Parlier HS Stadium Replacement

PBK PROJECT NO.: 250093
DSA FILE NO.: 10-H12
DSA APPLICATION NO.: 02-124002 _ PARLIER HS STADIUM REPLACEMENT

NOTICE TO BIDDERS

BUILDING
ELEVATIONS No.1 -
BUILDING N

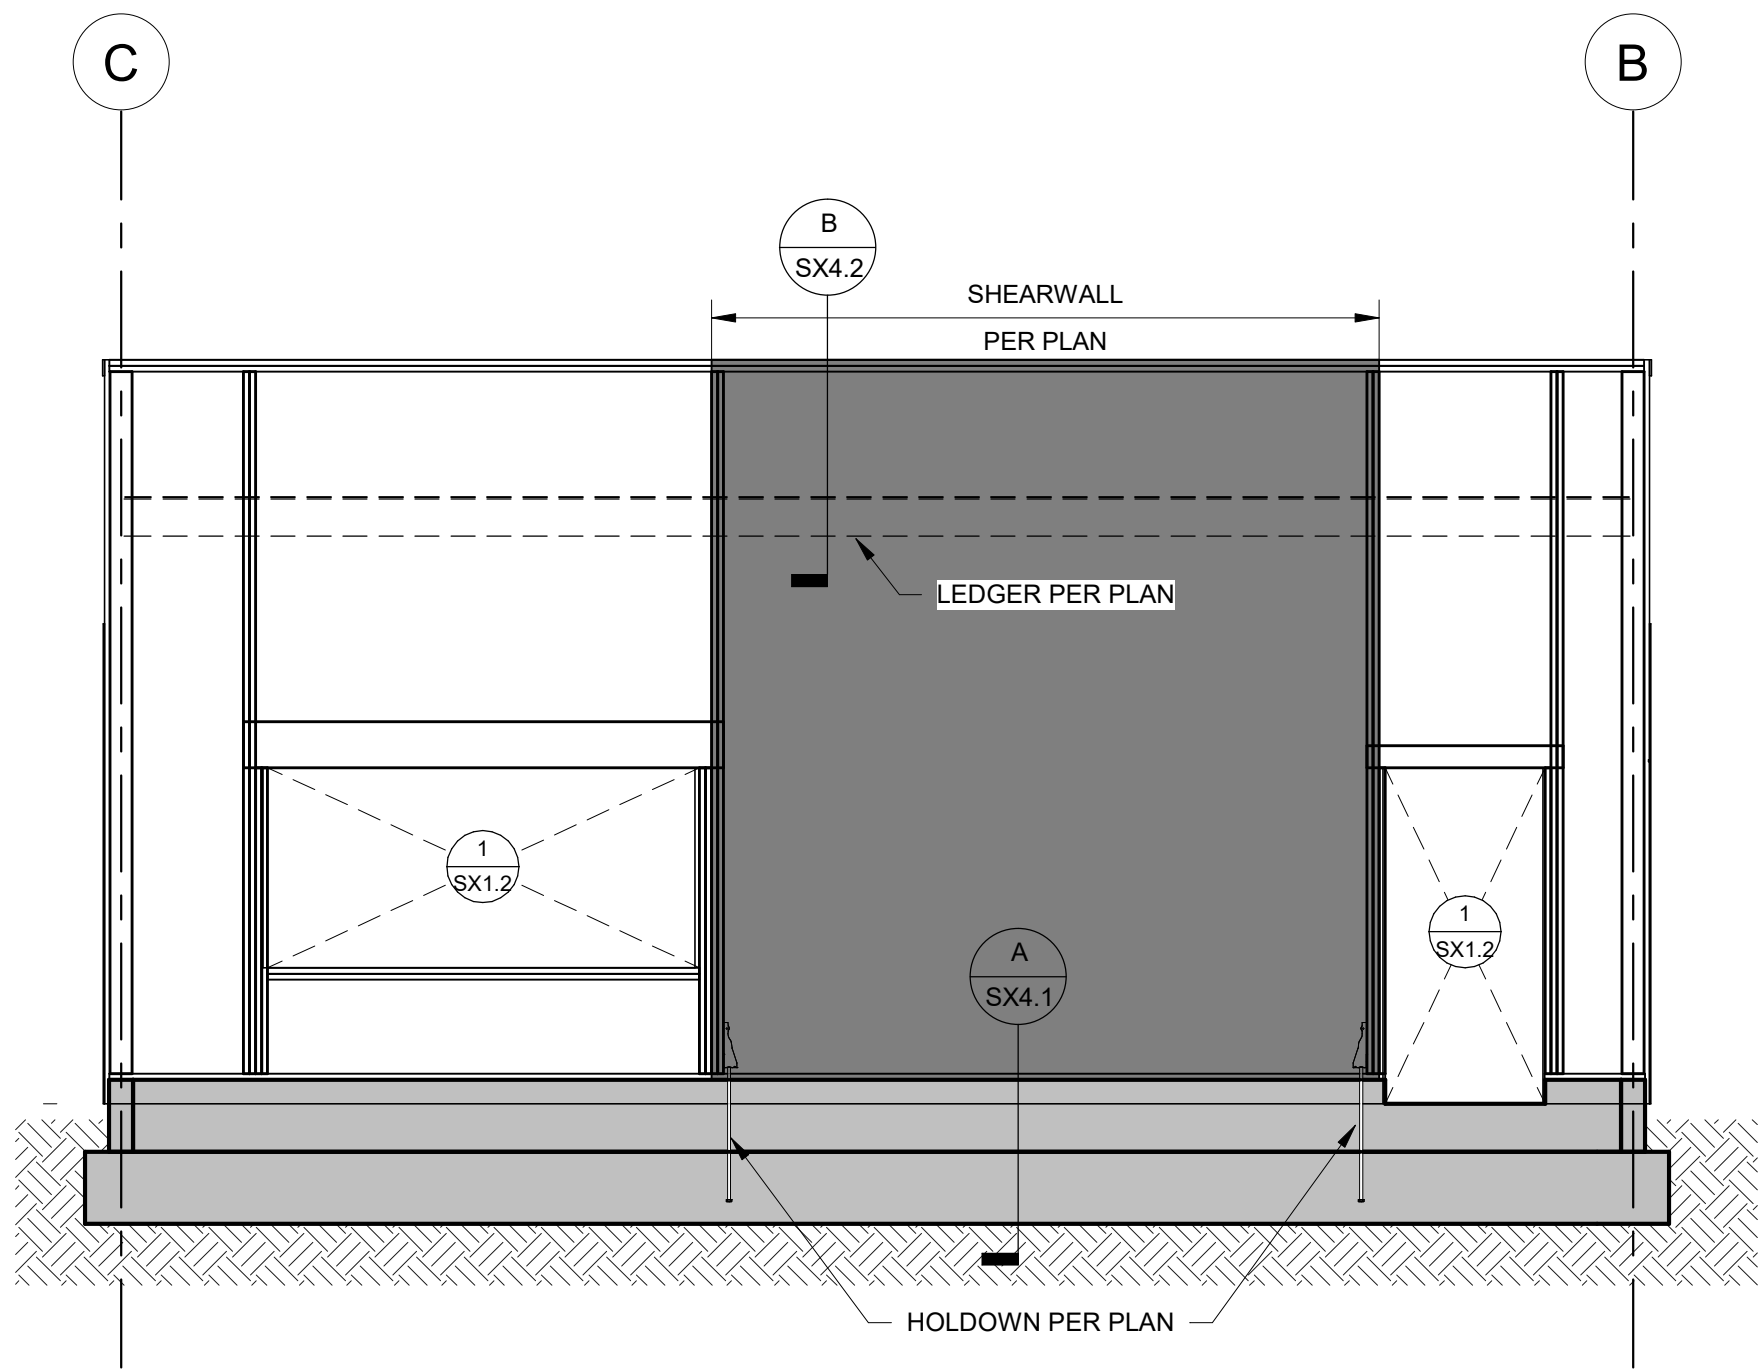
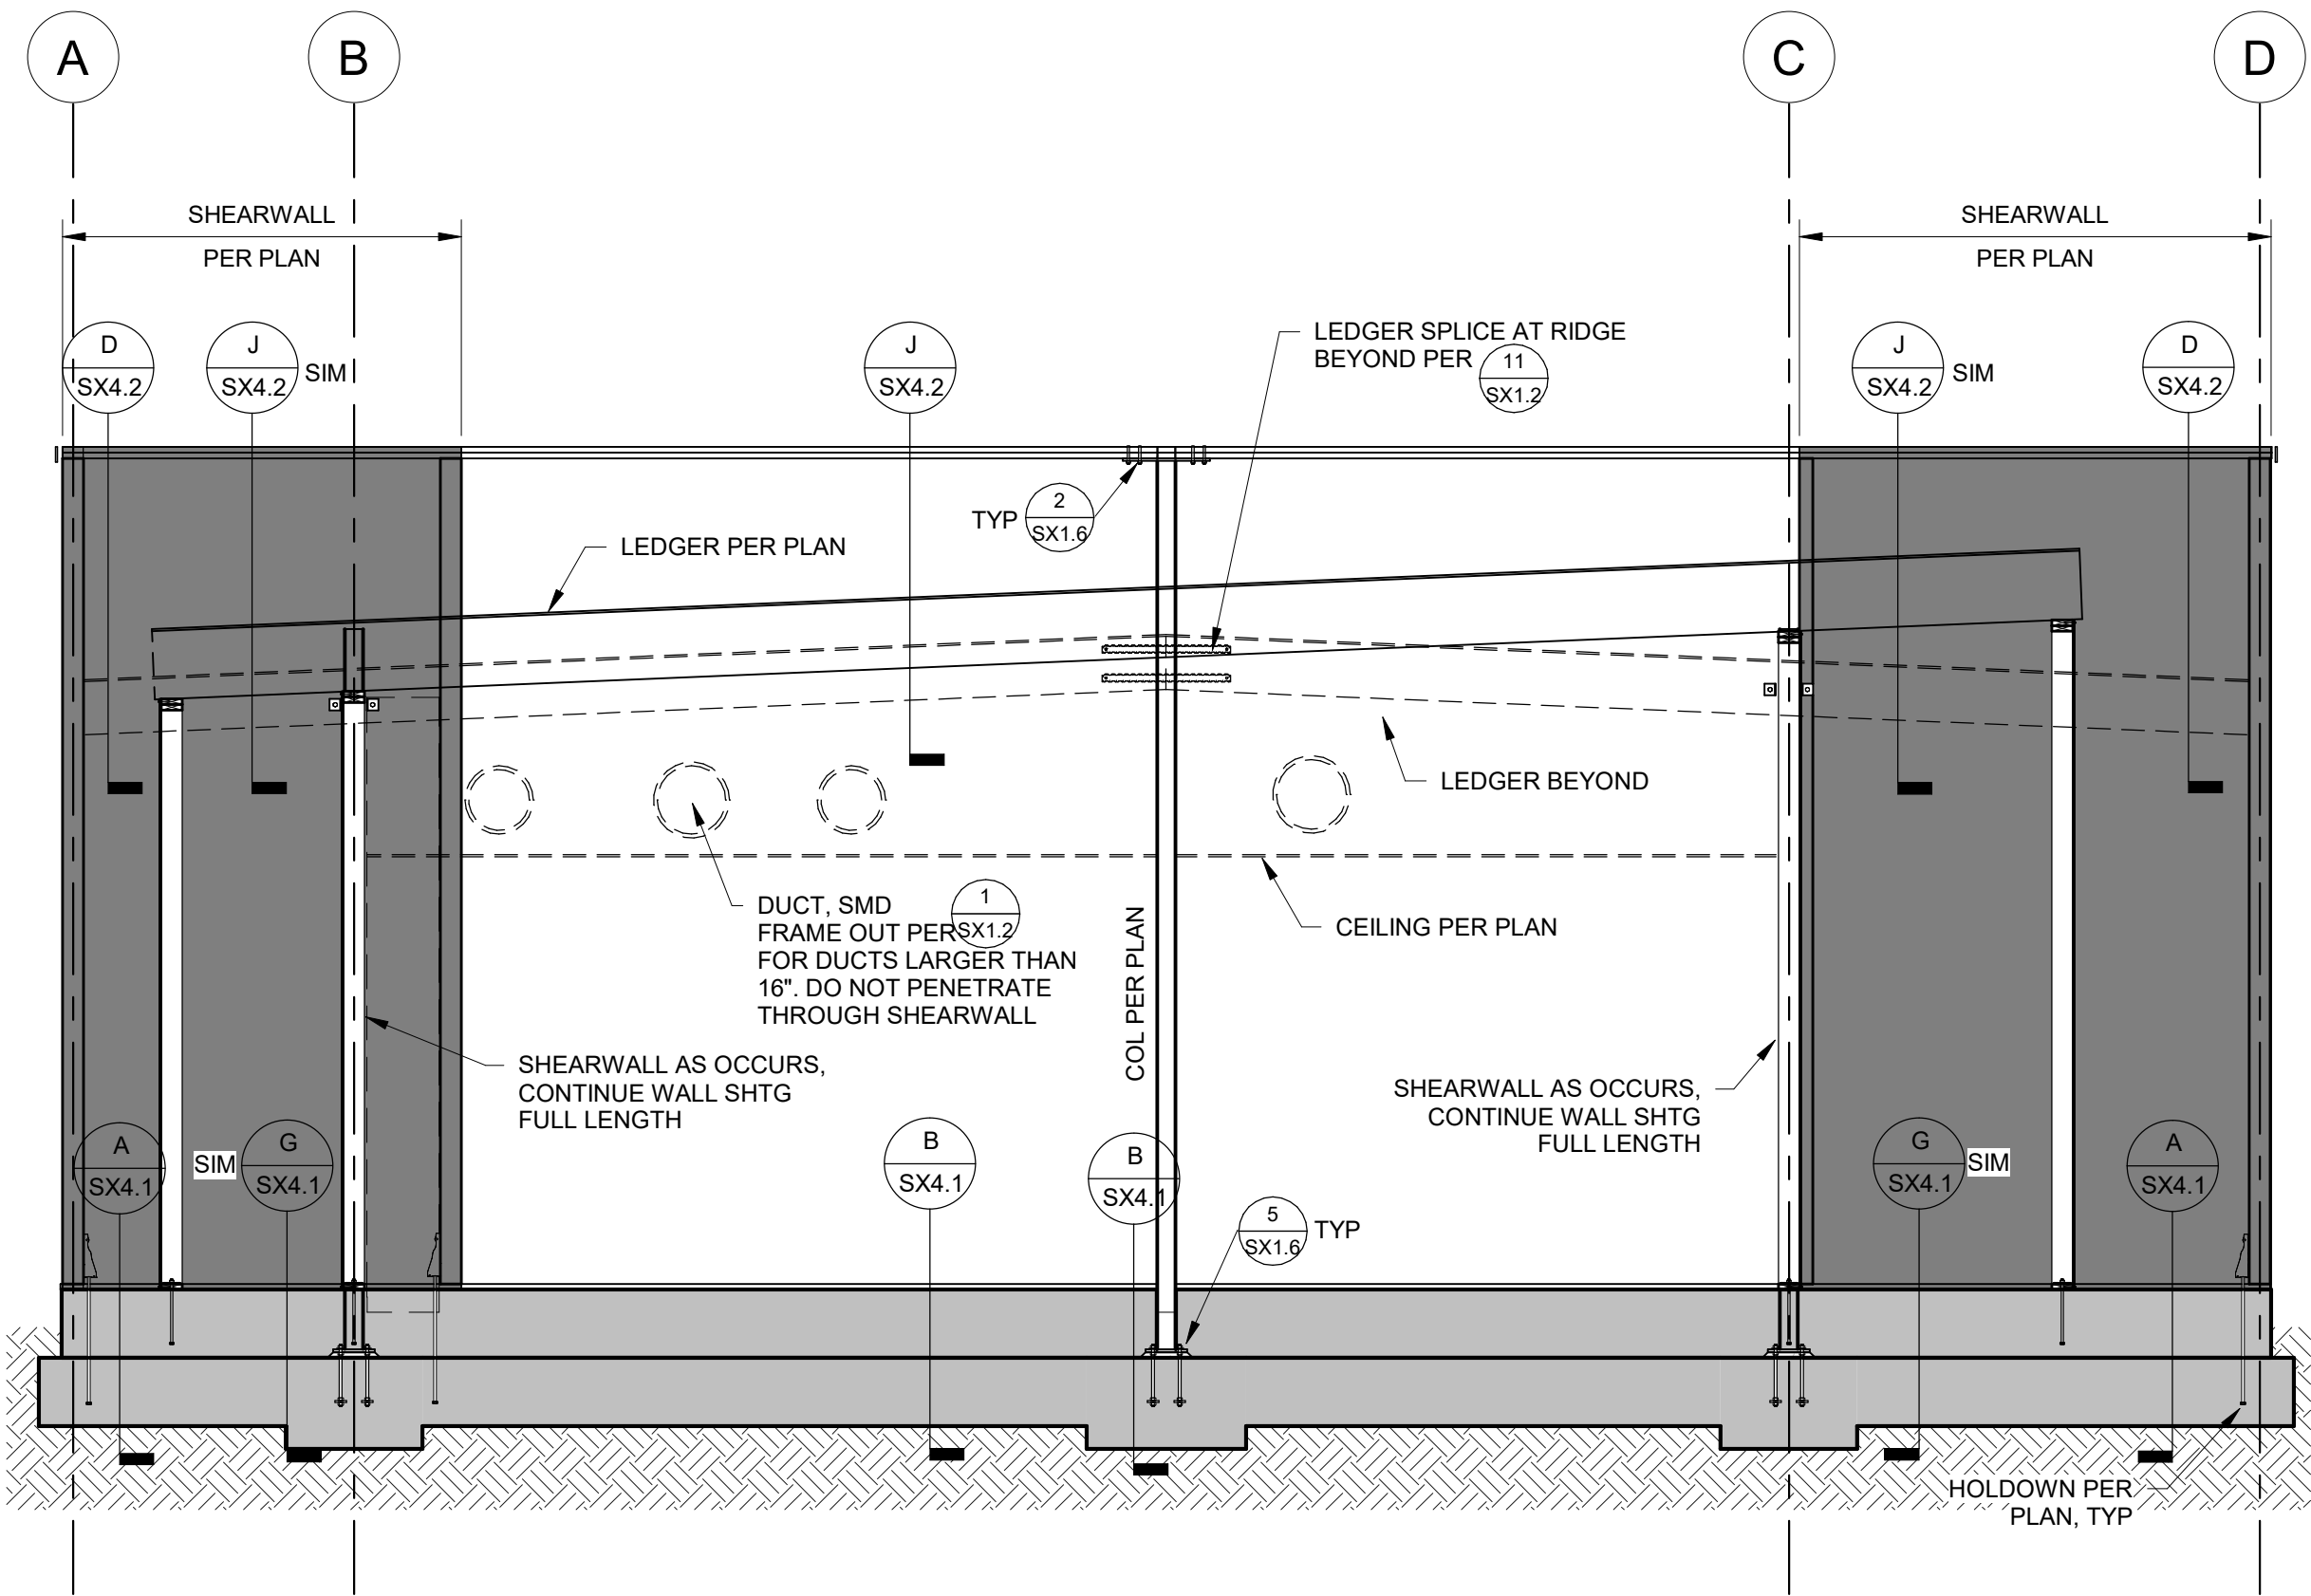
1. Refer to sheet SN3.3 "BUILDING ELEVATIONS No. 1- BUILDING N"
 - a. Remove and replace sheet SN3.3 "BUILDING ELEVATIONS No. 1- BUILDING N" with herein attached sheet SN3.3 "BUILDING ELEVATIONS No. 1- BUILDING N" identified with AD6 on the bottom right-hand corner.

Note: Changes to sheet shown on elevation 4/SN3.3
